Access Compliance Report

Public Rights-of-Way

(Curb Ramps)

Intersection ID: 17156	Main Street: BRIABEND_DR	Cross Street: FIRWOOD_LN	Location: SW
ADA ID: DA36E3EDFE37	Ramp Type: ParaDiag	Initial Pass/Fail: Fail	Overall Compliance: No
Codes/Mitigation Info/Possible Solution		Field Measurements/Component Compliance	
Severity Score: 13.75

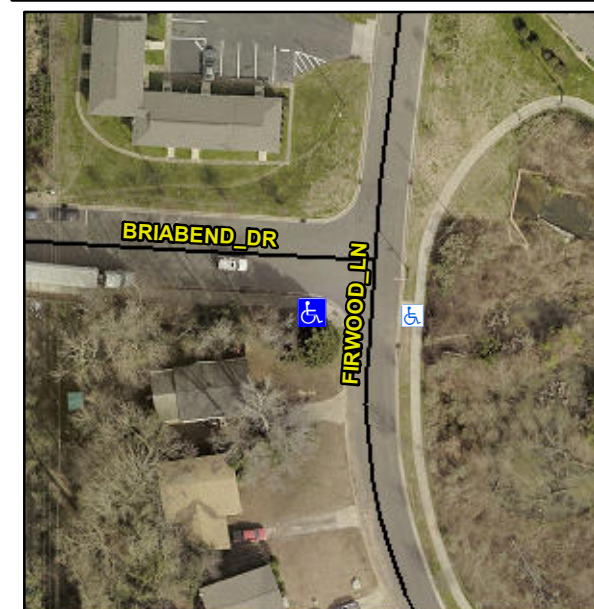
CURB GAP 1.0

R304.3.2, R304.5.3

Compliance	Description	Data	Compliance	Description	Data
N/A	Ramp Length LT (in)	45.0	N/A	Ramp Length RT (in)	57.0
Yes	Ramp Width LT (in)	72.0	Yes	Ramp Width RT (in)	72.0
Yes	Ramp Slope LT (%)	5.6	No	Ramp Slope RT (%)	9.0
Yes	Ramp XSlope LT (%)	1.2	No	Ramp XSlope RT (%)	2.8
N/A	Landing Length (in)	N/A	N/A	DWS Provided?	N/A
N/A	Landing Width (in)	N/A	N/A	DWS Contrast?	N/A
N/A	Landing Slope (%)	N/A	N/A	DWS Length (in)	N/A
N/A	Landing X Slope (%)	N/A	N/A	DWS Full Width?	N/A
N/A	Landing Curb? (Y/N)	N/A	N/A	DWS Offset (in)	N/A
N/A	Shared Landing?	N/A			
N/A	Gutter Ponding?	N/A	N/A	Gutter Slope (%)	N/A
N/A	Gutter Lip Ht (in)	N/A	N/A	Gutter X Slope (%)	N/A
N/A	Painted X Walk1?	No	N/A	Painted X Walk2?	No
	X Walk 1 Direction	To E		X Walk 2 Direction	To N
N/A	X Walk 1 Width (in)	N/A	N/A	X Walk 2 Width (in)	N/A
	X Walk 1 Slope (%)	3.4		X Walk 2 Slope (%)	1.1
	X Walk 1 X Slope (%)	0.1		X Walk 2 X Slope (%)	0.8
N/A	Ramp inside XWalk1?	N/A	N/A	Ramp inside XWalk2?	N/A

Remove & Replace Curb Ramp With Two New Directional Ramps or Equivalent.
